Re: Request to Modify Remedial Action Work Plan
Focused Soil Investigation and Alternative Soil Removal Plan
RAWP Task 6.2.6 - Cover System
Former Labelon Corp. Facility, Site Code C835016
10 Chapin Street, Canandaigua, New York

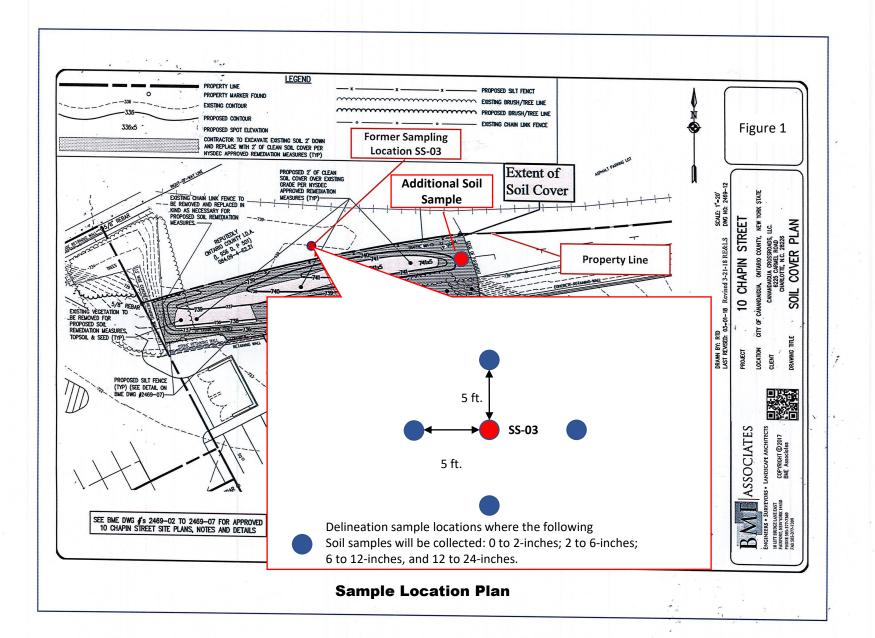
To further define the area the original SS-03 location will be located with either a GPS field instrument or if the GPS is unsuccessful, a licensed surveyor will be employed. Soil sampling will include the collection of soil samples from four locations for chemical analysis. The samples will be obtained in a grid located 5-feet north, south, east and west of sample SS-3, see Figure 1. At each of the four soil sample locations, three samples will be collected at the 0 to 2-

inch; 12-inch and 24-inch depths below the ground surface. These intervals were selected to further evaluate the extent of contamination and to define the lower limits of the proposed remediation. In addition, one surface soil sample will be collected on the east side of the original cover area.

If soil contamination is found at levels above the applicable RRSCO extending beyond the sampling points the original task in the RAWP will be implemented except for the excavation along the retaining wall and building foundation. If contamination above the RRSCO is not found to extend beyond the sampling locations, then this the modified RAWP task will include the removal of the soil to a depth of up to 2-feet or to a shallower depth where RRSCO are satisfied. The horizontal limits of the excavation will be delineated by the sampling points grid. The excavation will be filled with approved clean imported soil forming a cover as shown in Figure 2. The soil to be imported will be analyzed following DER-10 and sample analysis results submitted to NYSDEC for approval prior to use. The final thickness of imported fill will be 2.0 feet as originally proposed in the Ravi RAWP.
